PLATTE SELF STORAGE WATER & UTILITY SERVICE PLAN COVER SHEET MAY 2024

PLATTE SELF STORAGE

GRADING AND EROSION CONTROL PLAN

PLATTE SELF STORAGE
GRADING AND EROSION CONTROL PLAN
INTERIM EROSION CONTROL PLAN - SOUTH SIDE

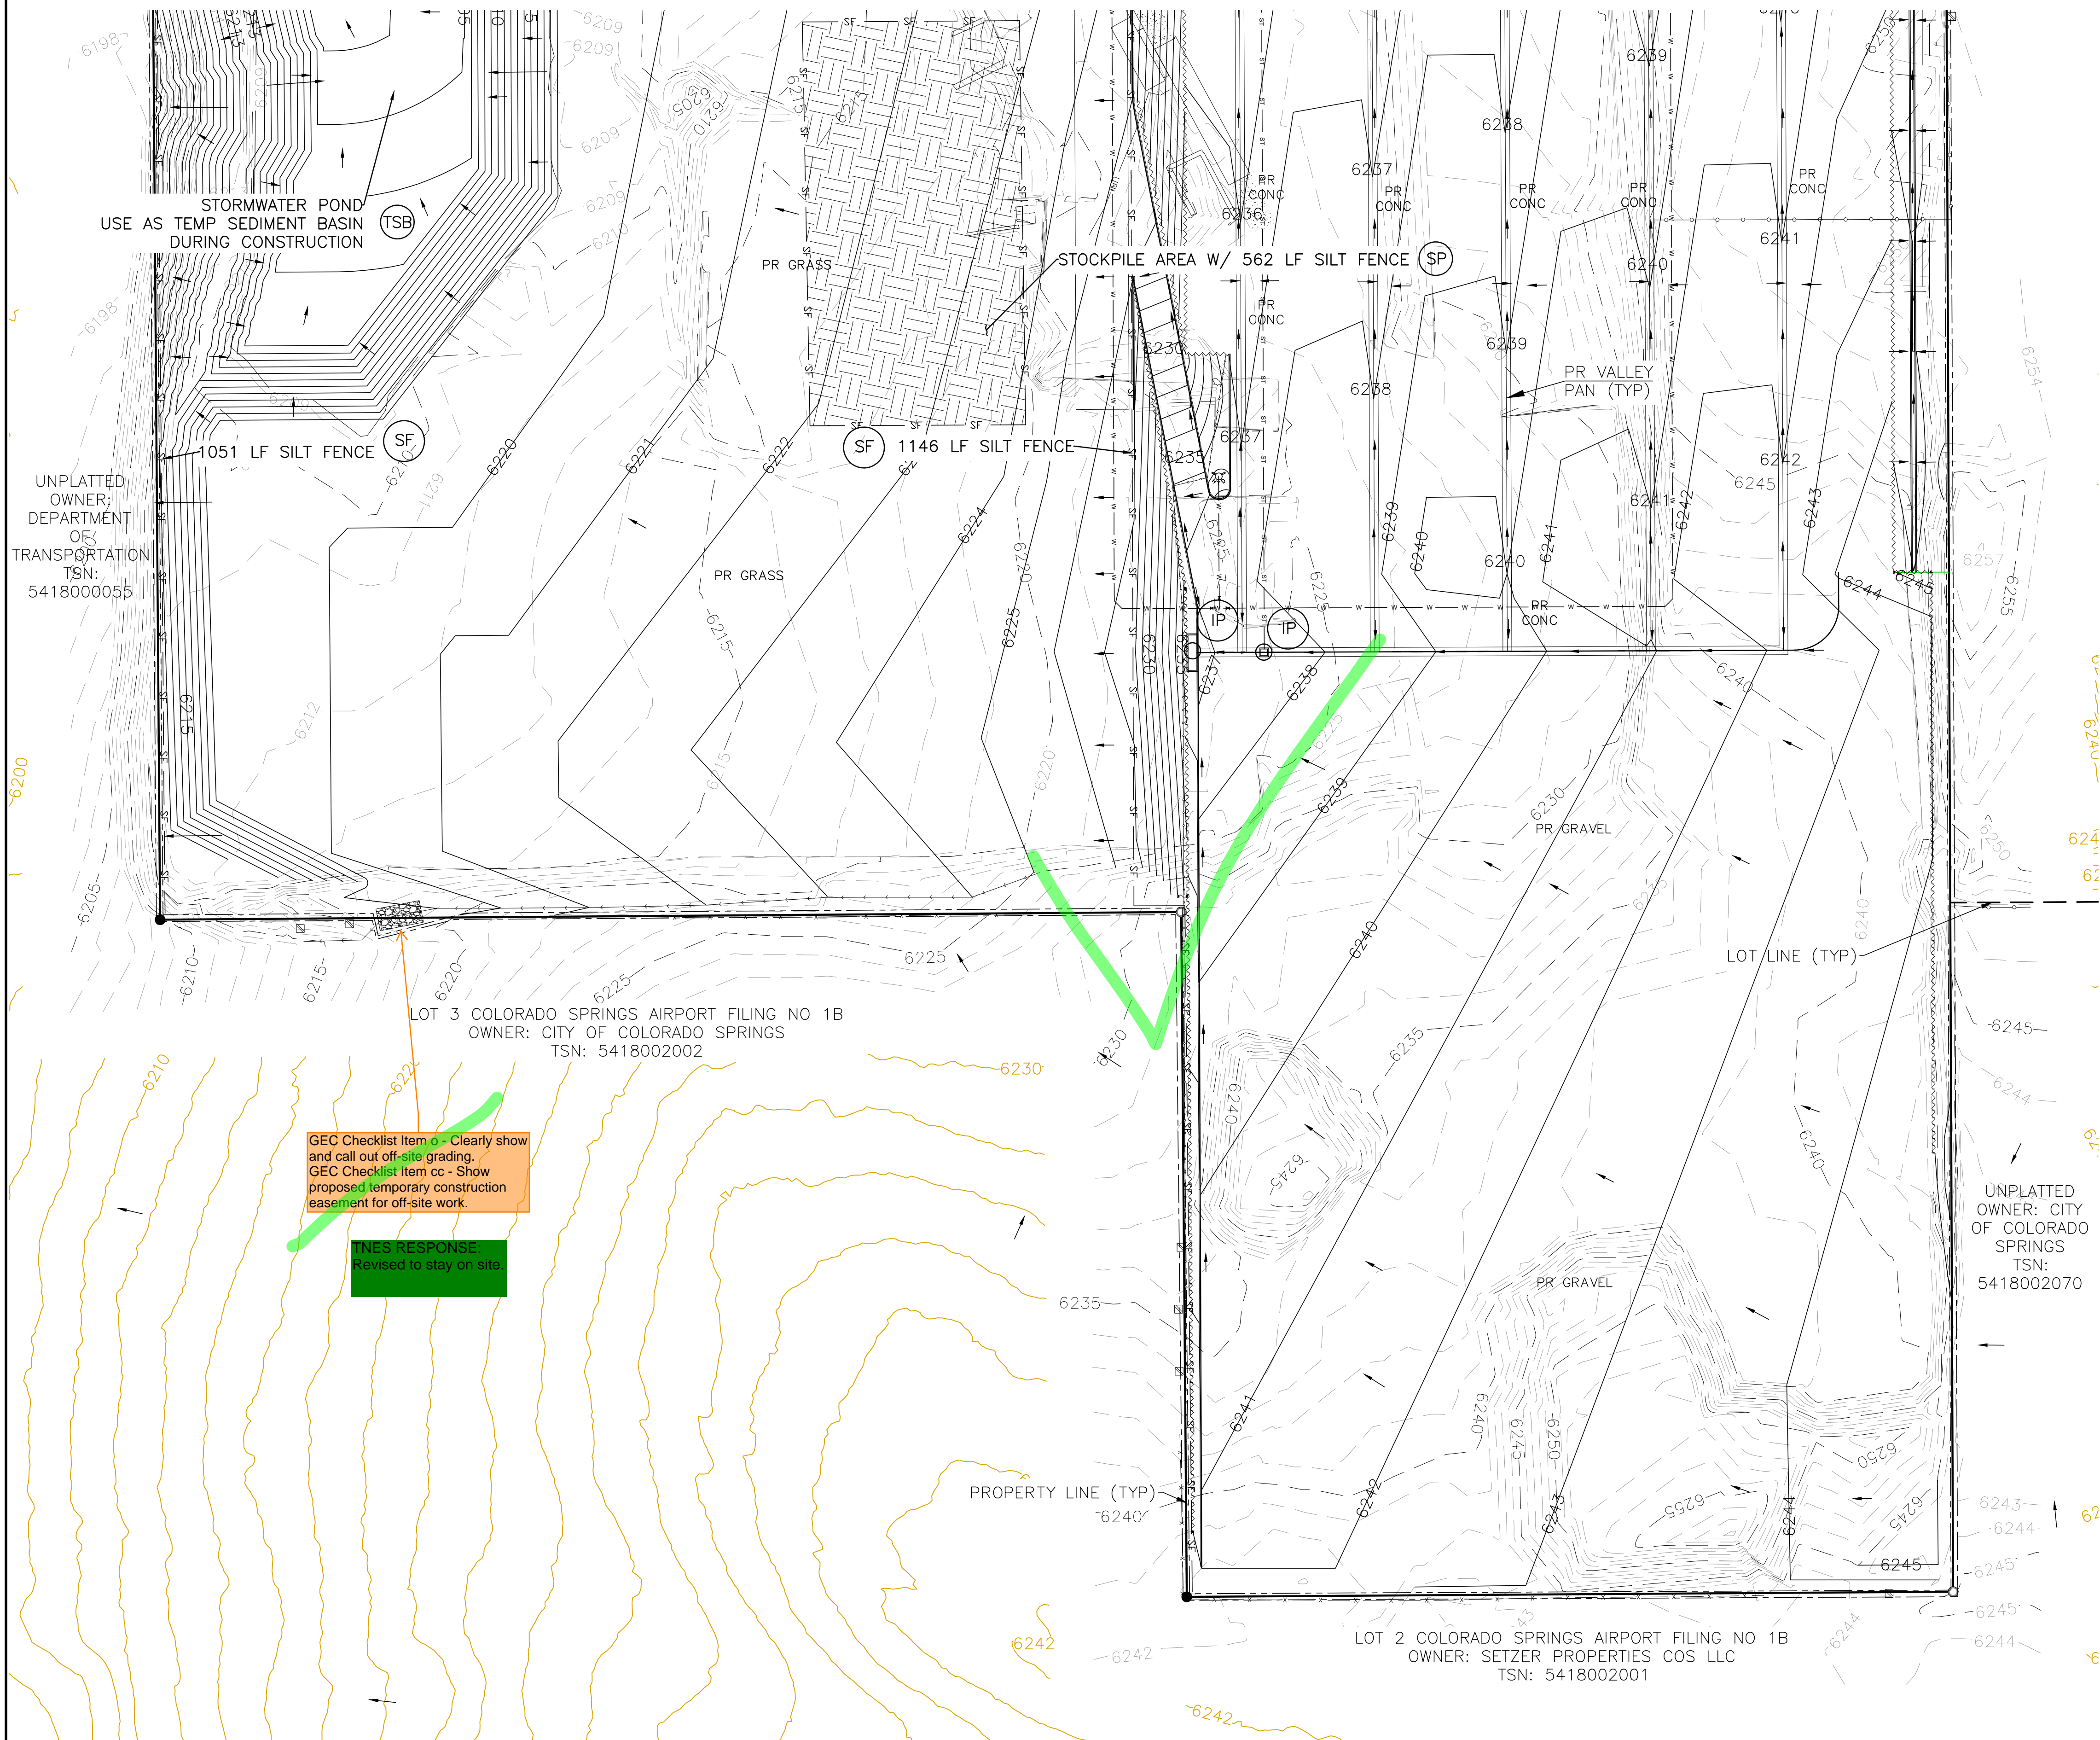
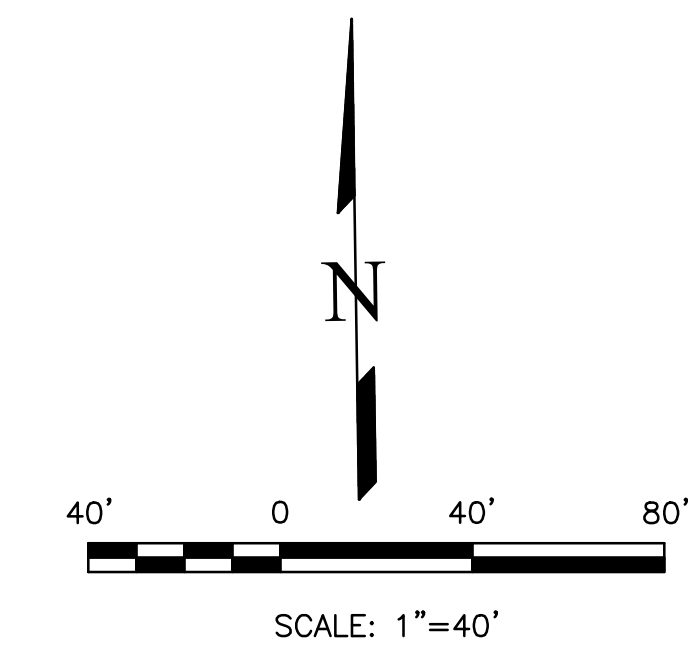
GEC Checklist Item o - Clearly show and call out off-site grading.
GEC Checklist Item cc - Show proposed temporary construction easement for off-site work.

DESIGNER RESPONSE:
Revised to stay on site.

VERTICAL EC PLAN - NORTH SIDE

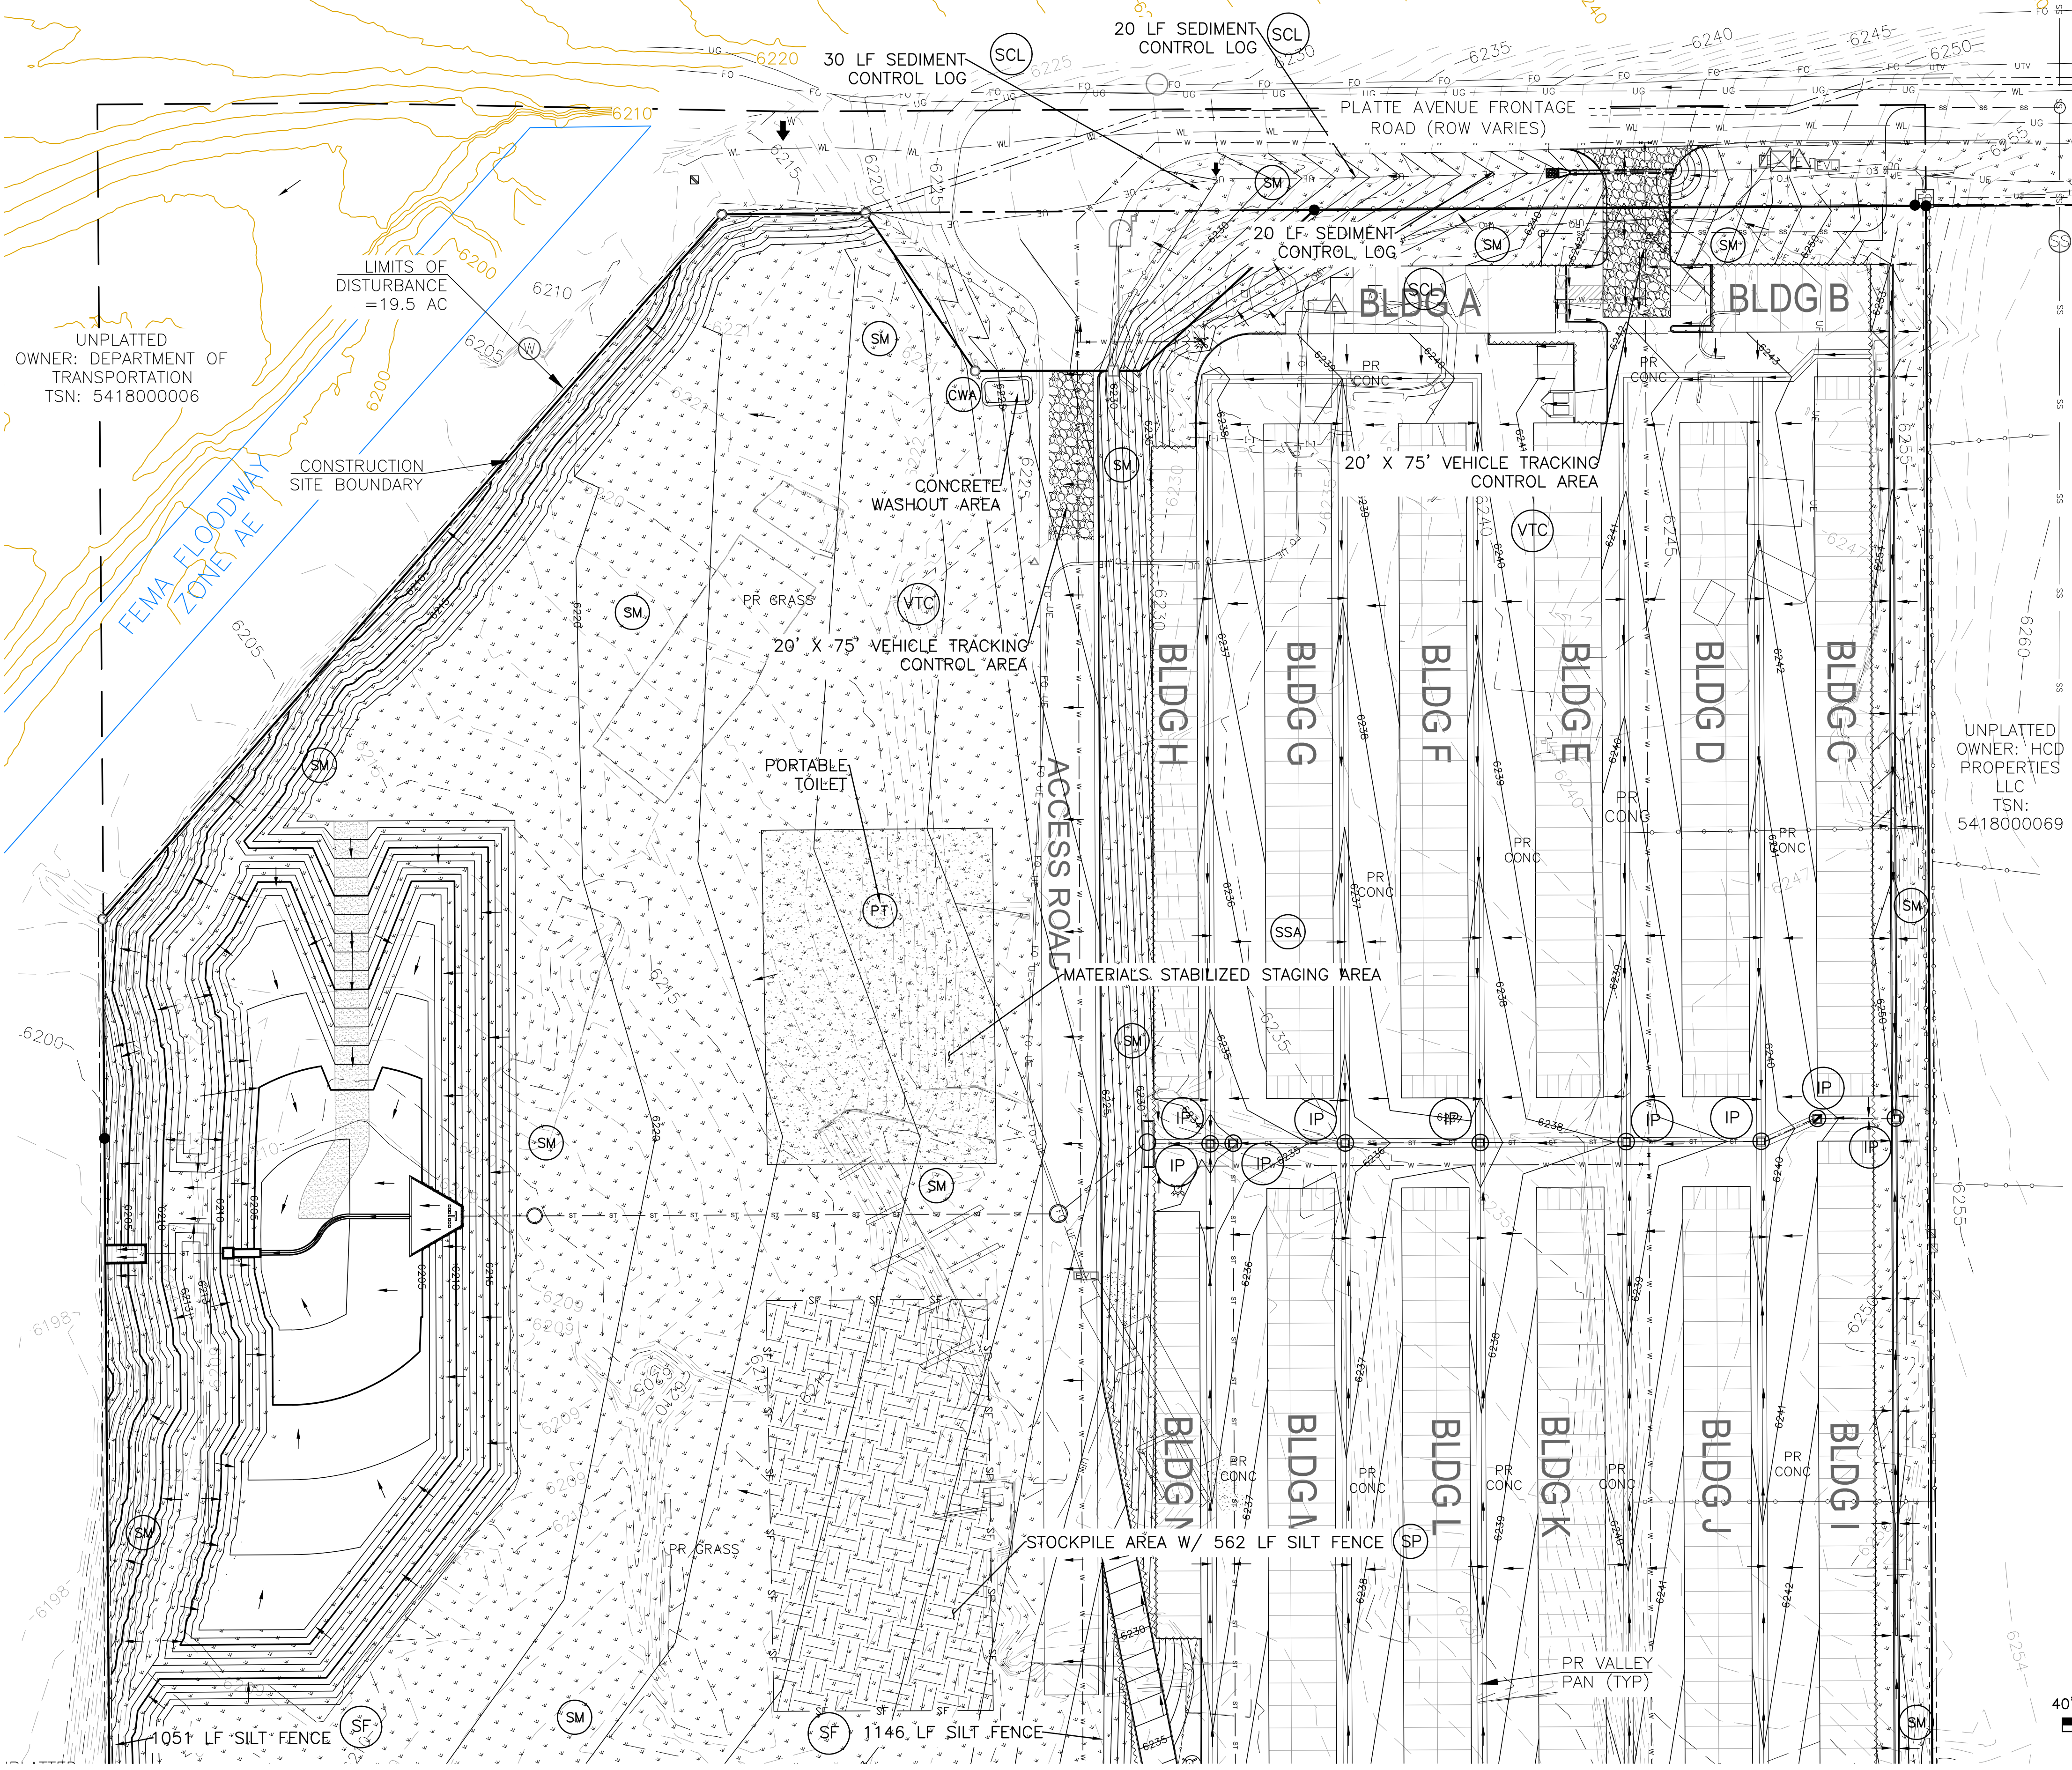
This should read the final plan - as in only permanent stabilization/ long term VQ BMPs. Either change title and remove all temp BMPs or add the Final EC Plan after.

ENR RESPONSE: Changed to final.
